PSI DWG # V049-8-69

| ITEM  | QTY. | PART NO. | DESCRIPTION   |
|---|------|----------|---|
| <small>                     GNB CORPORATION<br/>                     SCIENTIFIC AND INDUSTRIAL EQUIPMENT<br/>                     20271 San Joaquin St.<br/>                     HAYWARD, CALIFORNIA 94544<br/>                     (510) 441-1200 FAX: (510) 441-0828                 </small>   |      |          | TITLE<br><b>OUTLINE, GATE VALVE<br/>                     G48ESB - WELD/WELD</b> |
| USED ON<br>N/A  |      |          | PART NO.<br>103849-01   |

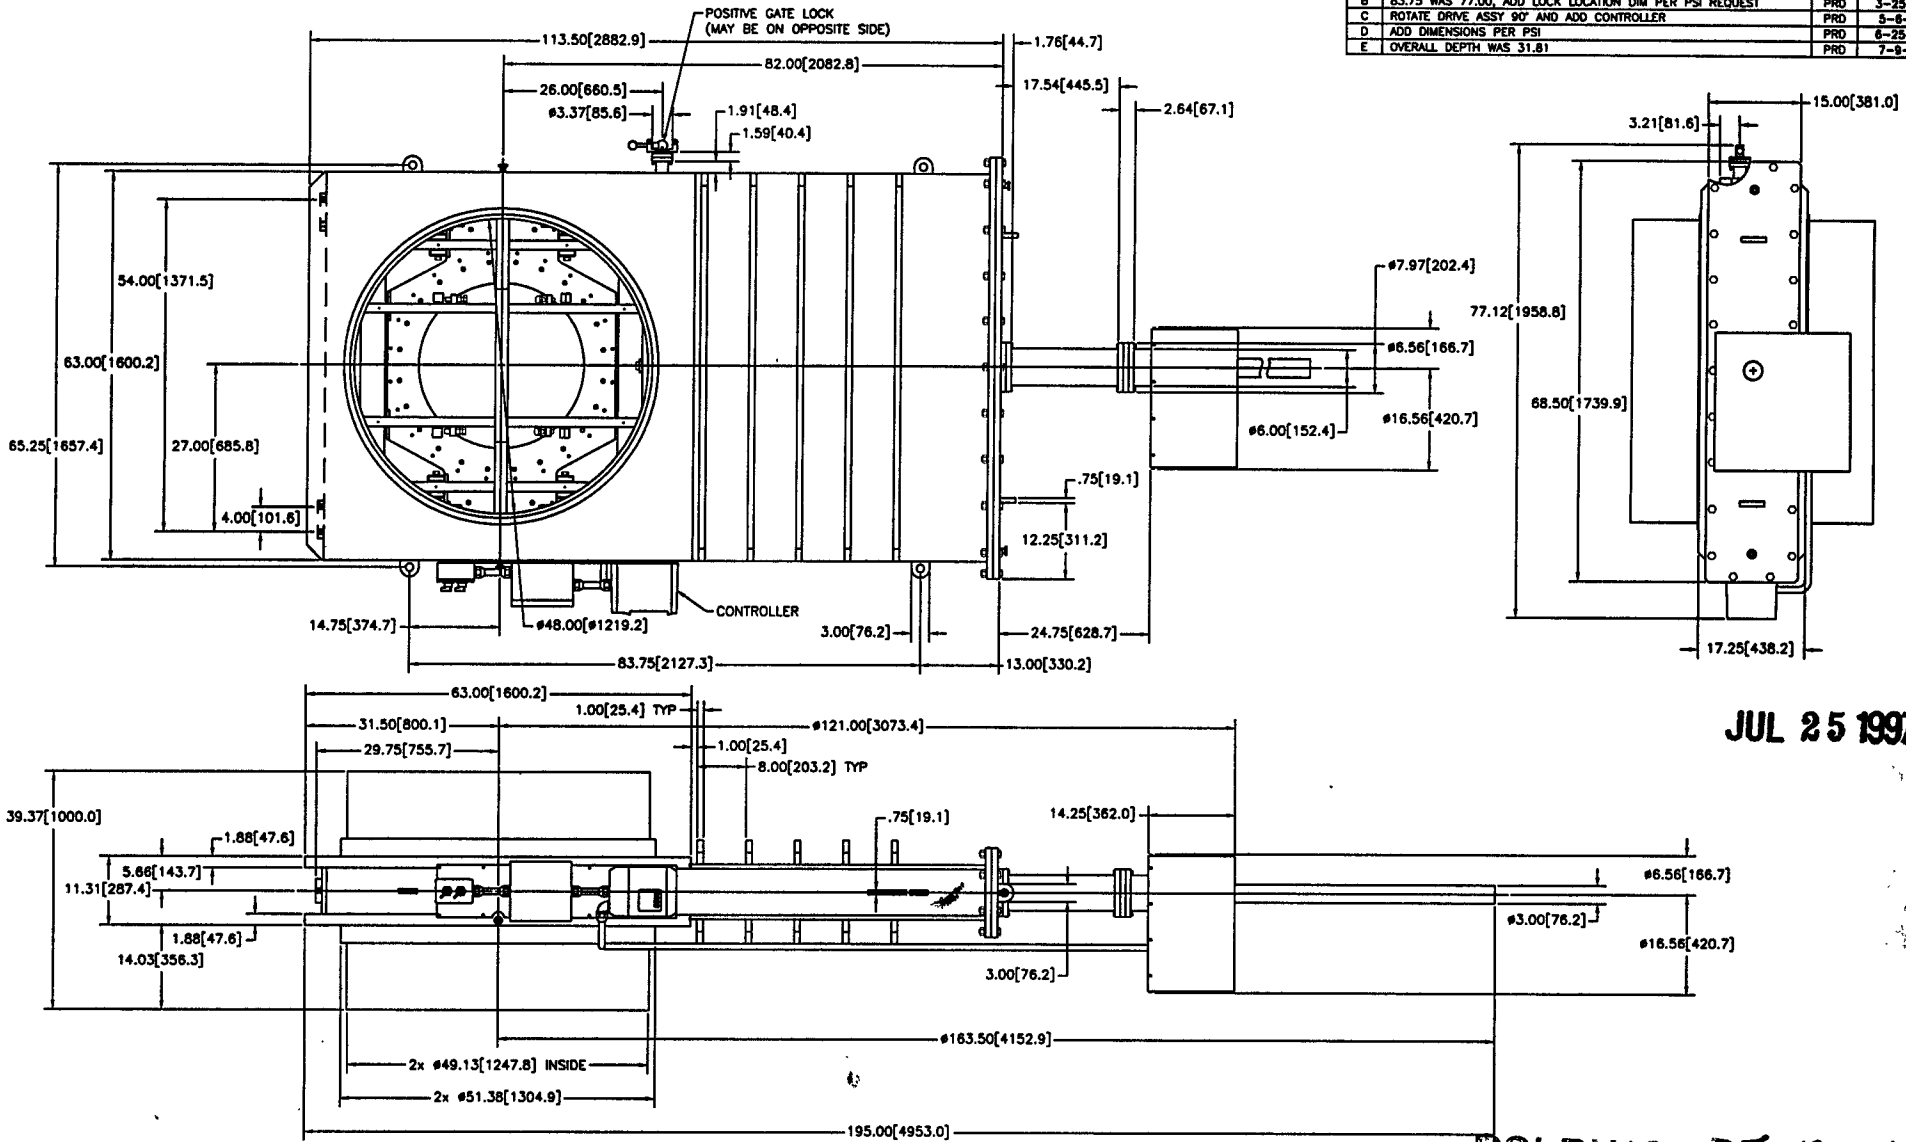
| REVISIONS |  |          |         |
|-----------|--|----------|---------|
| B         | 83.75 WAS 77.00, ADD LOCK LOCATION DIM PER PSI REQUEST | PRD      | 3-25-97 |
| C         | ROTATE DRIVE ASSY 90° AND ADD CONTROLLER               | PRD      | 5-6-97  |
| D         | ADD DIMENSIONS PER PSI                                 | PRD      | 6-25-97 |
| E         | OVERALL DEPTH WAS 31.81                                | PRD      | 7-8-97  |
